Town of Arlington, MA Redevelopment Board

Agenda & Meeting Notice August 7, 2017

RE: Design Changes to 483 Summer St Project

**RE: Environmental Design Review & Special Permit Request Relating to
887 Massachusetts Avenue, Arlington, Massachusetts**

C-1

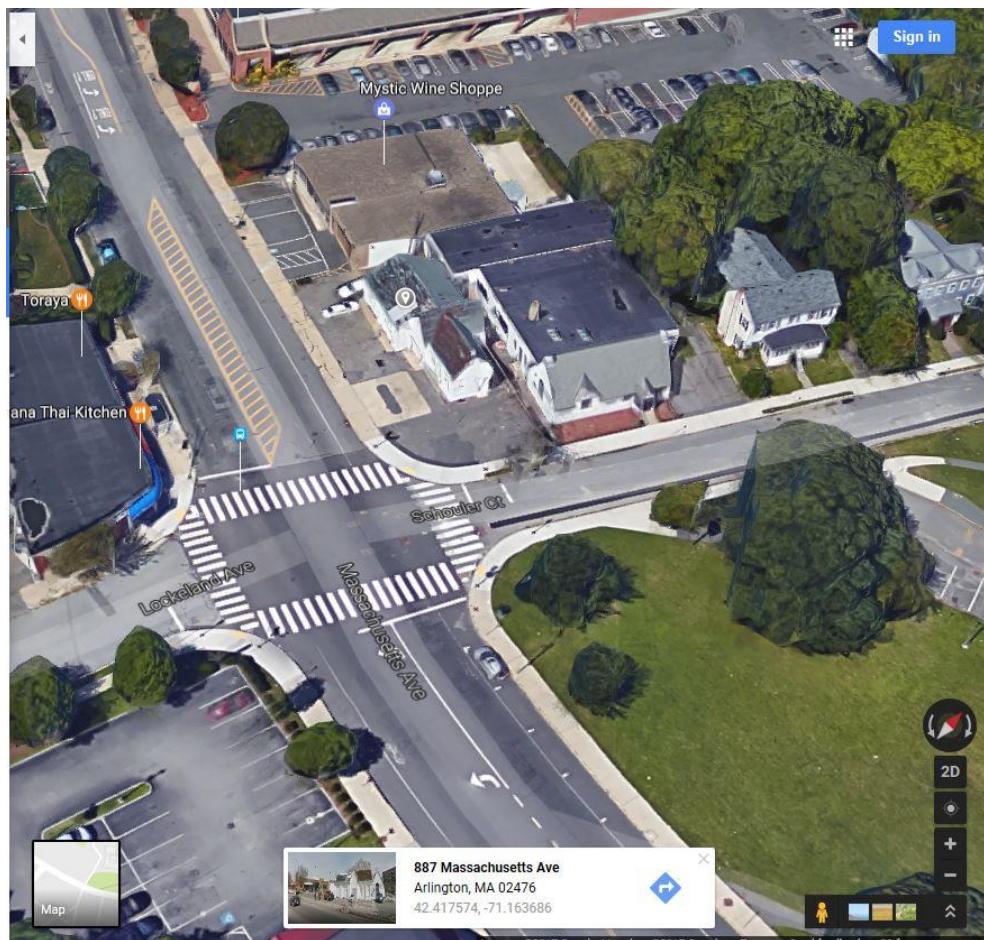
The parking proposal as set forth within the substance of Plan C-1 shows the compact parking spaces D, E, and F and the regular parking spaces being A, B and C.

Also, as can see from the revised parking plan, additional open space has been created with the reduction of three of the regular parking spaces to three compact spaces.
